**Byers Gill Solar
EN010139**

Statement of Common Ground with Great Stainton Parish Meeting

Deadline 6 -December 2024

Revision 2

RWE Priority Areas

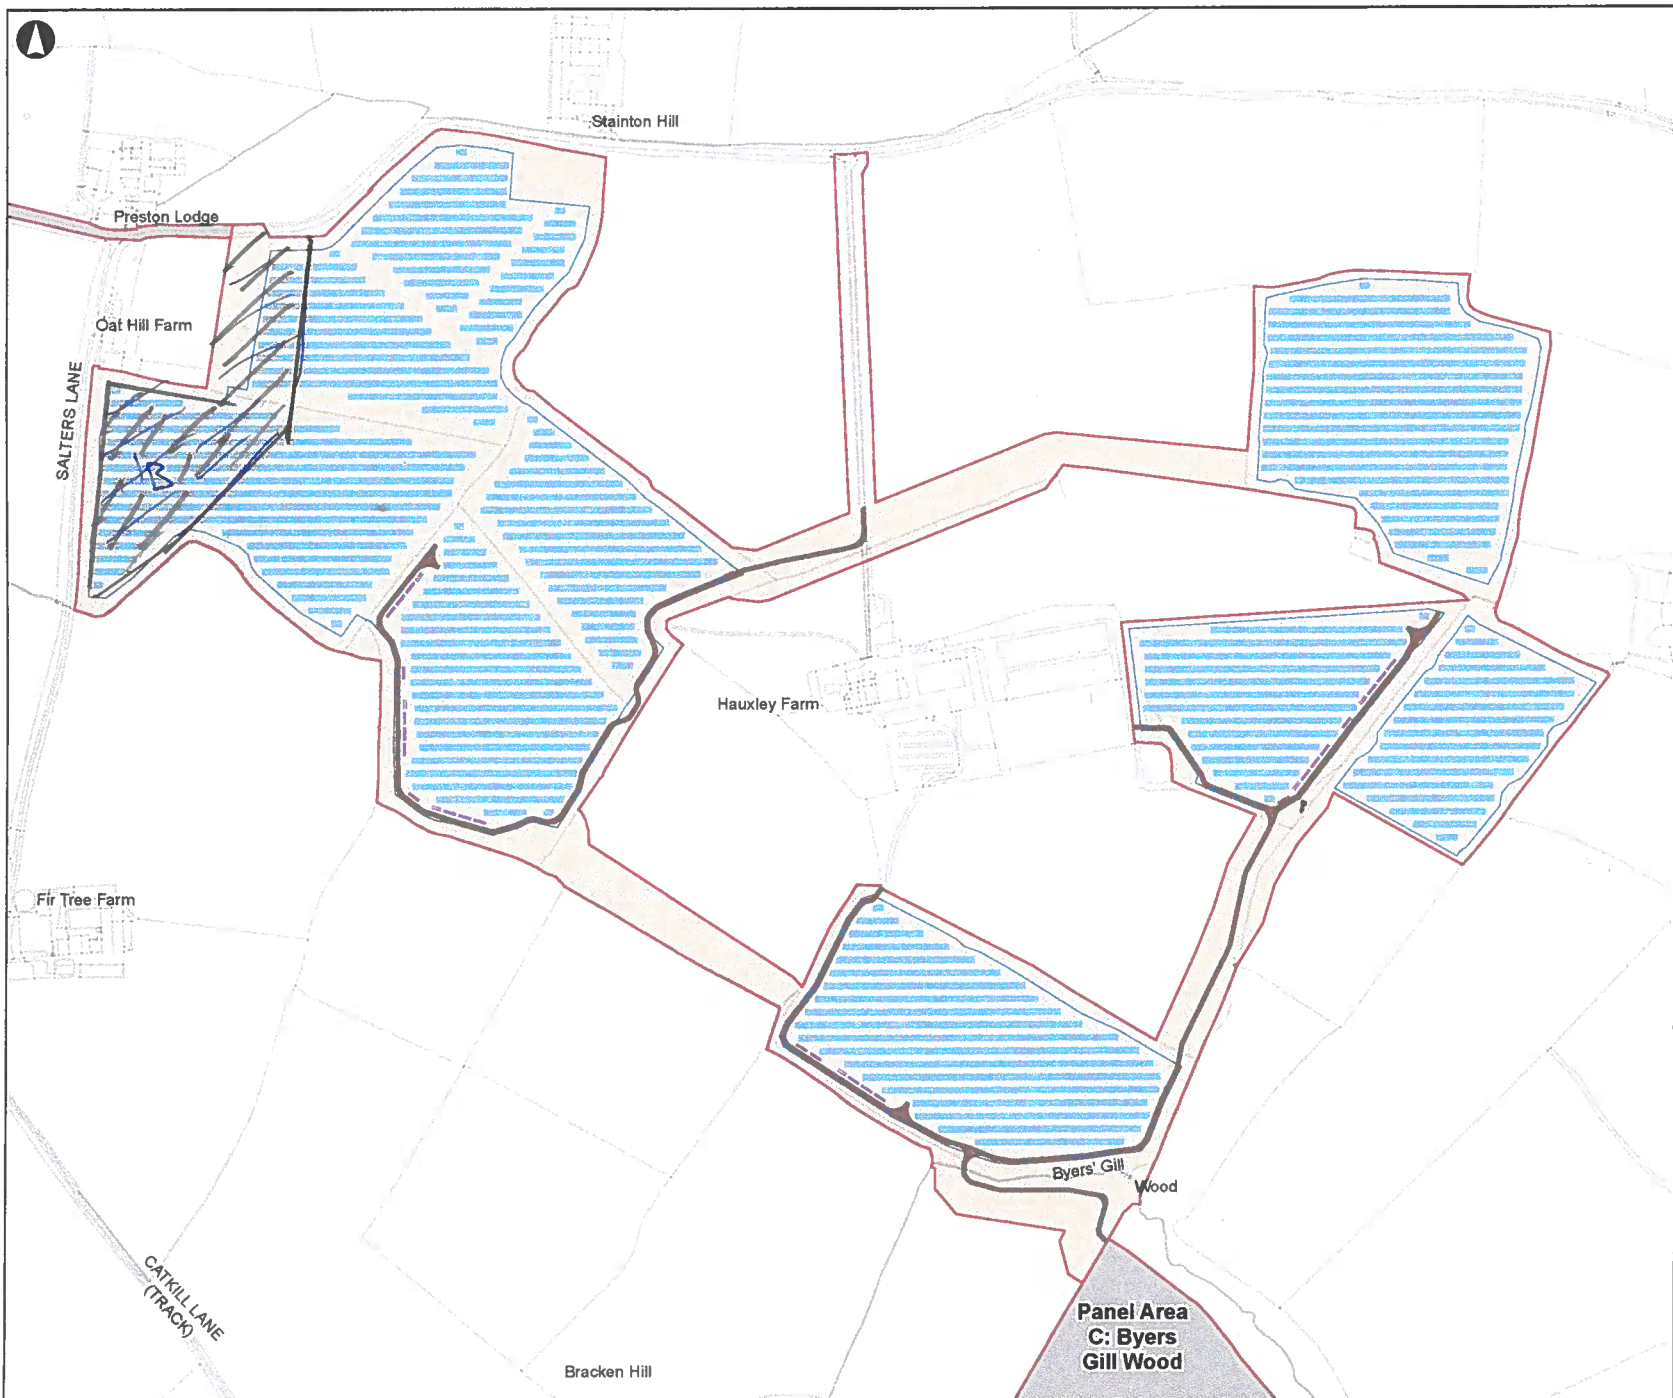
PV panels offset from residence at Downland Farm with proposed relaxation of hedge flailing together with hedgerow infill to provide biodiversity, screening and landscape structure enhancement

Proposed tree planting to the south of PV panels to enhance screening from rerouted PRoW and residences on the northern edge of Bisphopton

Proposed community orchard accessible via existing recreation ground to provide a buffer between PV panels and Bisphopton. Proposed hedgerow and enhanced grass sward to enhance biodiversity, screening and landscape structure

Proposed biodiversity offset from Mill Lane to provide a buffer between PV panels and popular walking route

Proposed relaxation of hedge flailing together with hedgerow infill and new hedgerow trees to provide biodiversity, screening and landscape structure enhancement

Proposed carpark for school use with secure access to school

Proposed forest school and sensory garden with secure access from Bisphopton Primary School to provide learning activities within a naturally wooded, biodiverse and stimulating environment to enable appreciation of the natural world

Drawing Title
**Figure 2.6
 General Arrangement Panel Area D**

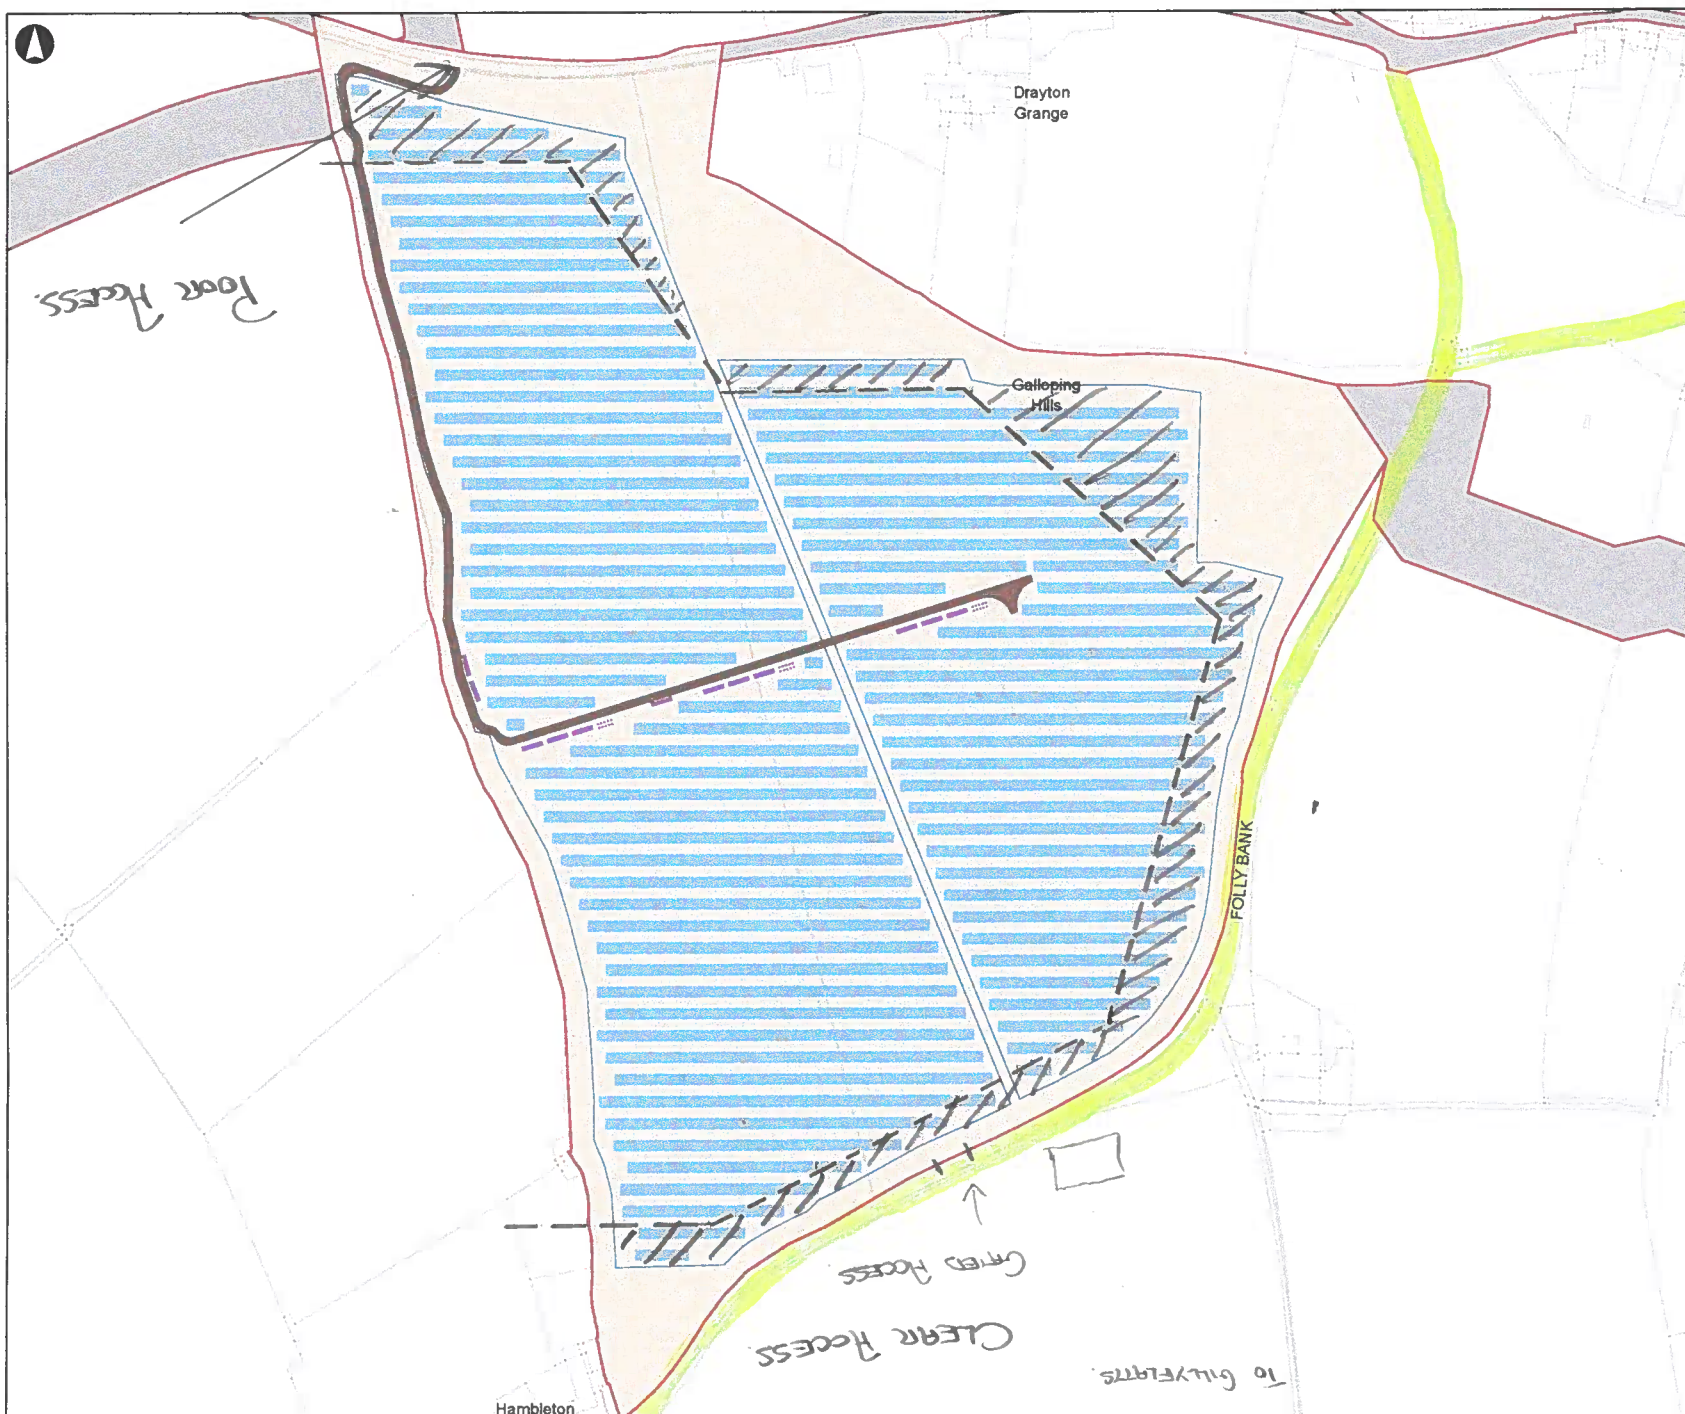
- Bunding and planting
- Panel Areas to be removed with grading 1A (Highest priority).
- Semi mature planting to fill gap in existing hedge

1A= Areas Highly Visible or extremely close to village
 1B= Areas significantly close or visible

Drawing Title
**Figure 2.8
General Arrangement Panel Area F**

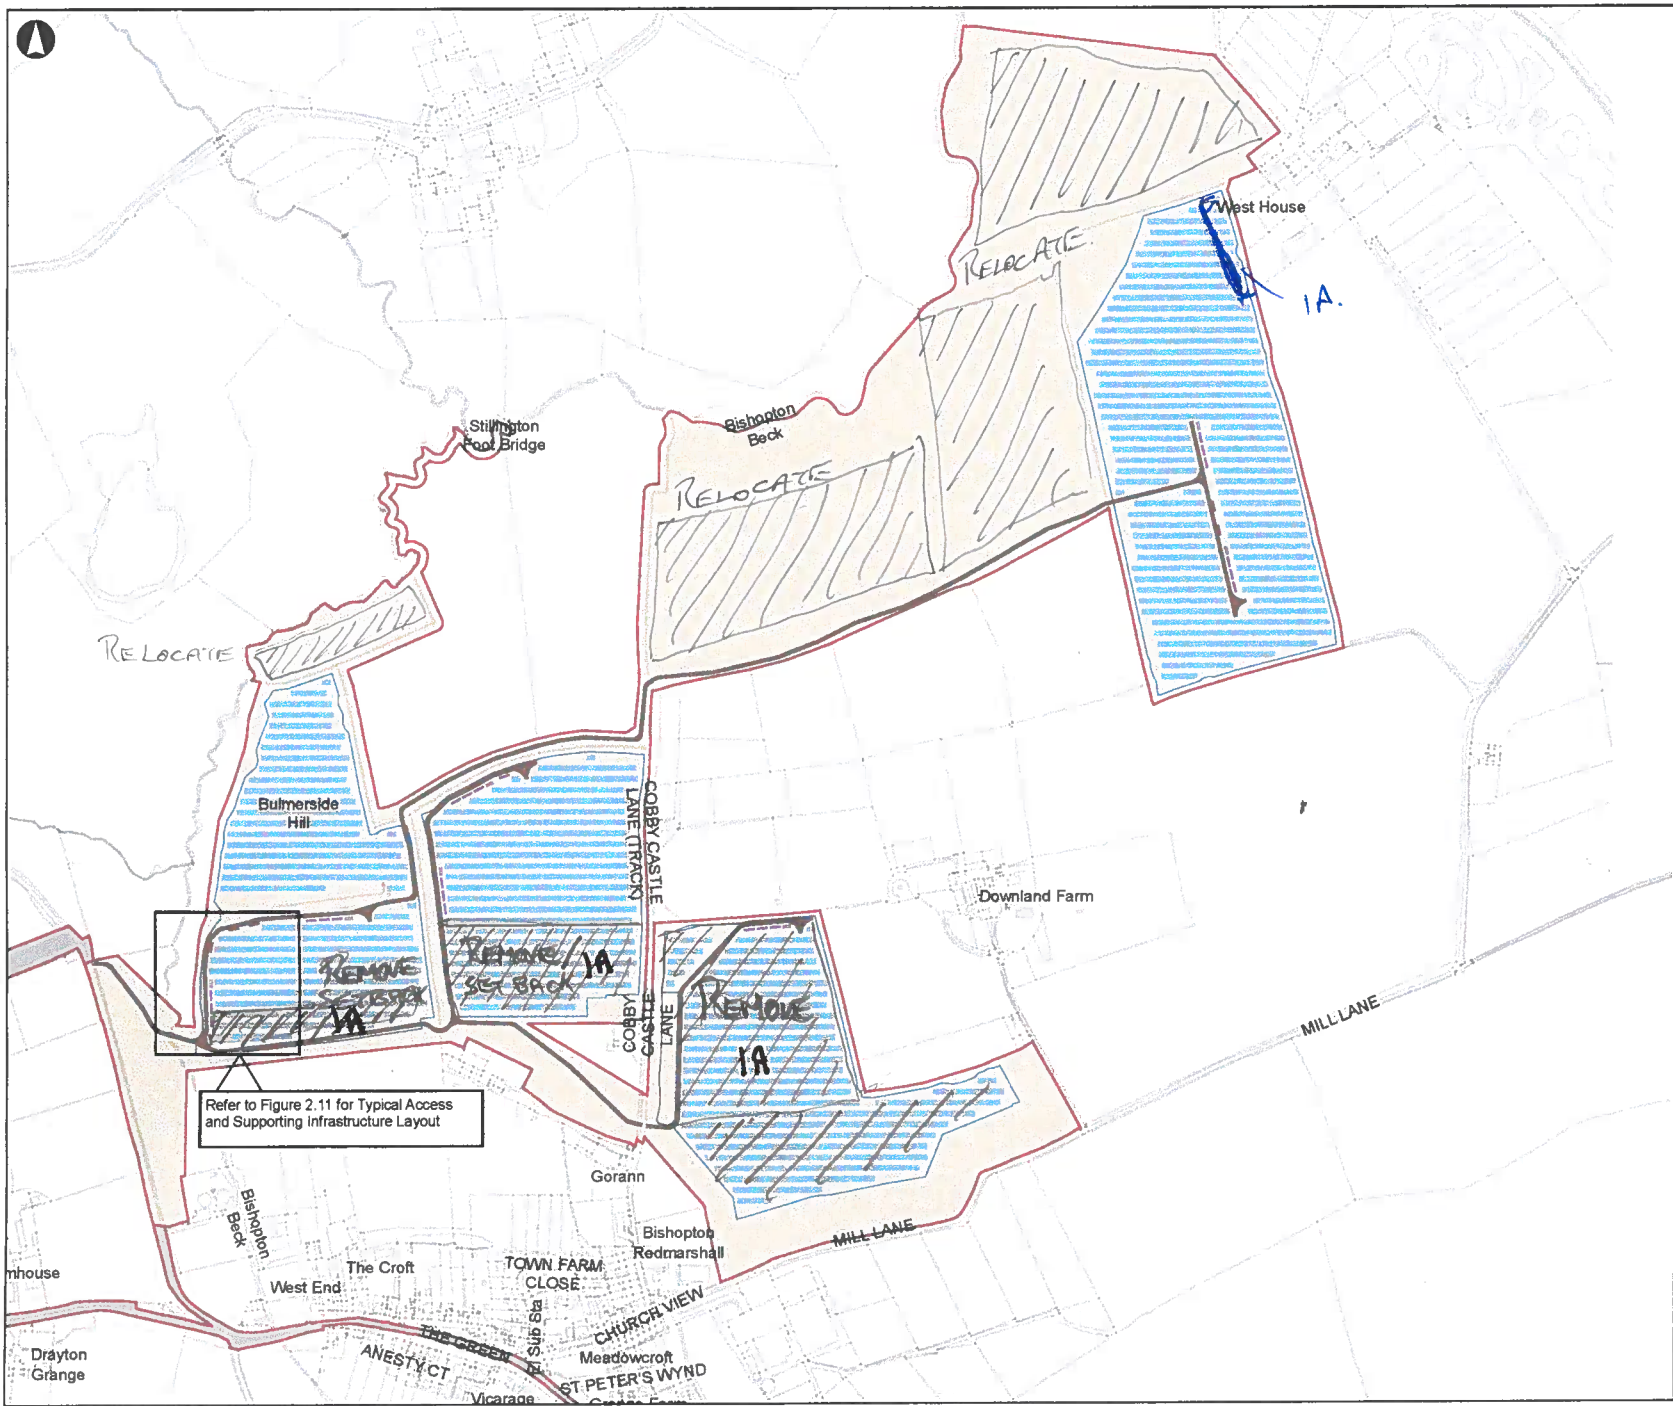
**IA - PANEL AREAS
HIGHLY VISIBLE/MODIFY!**
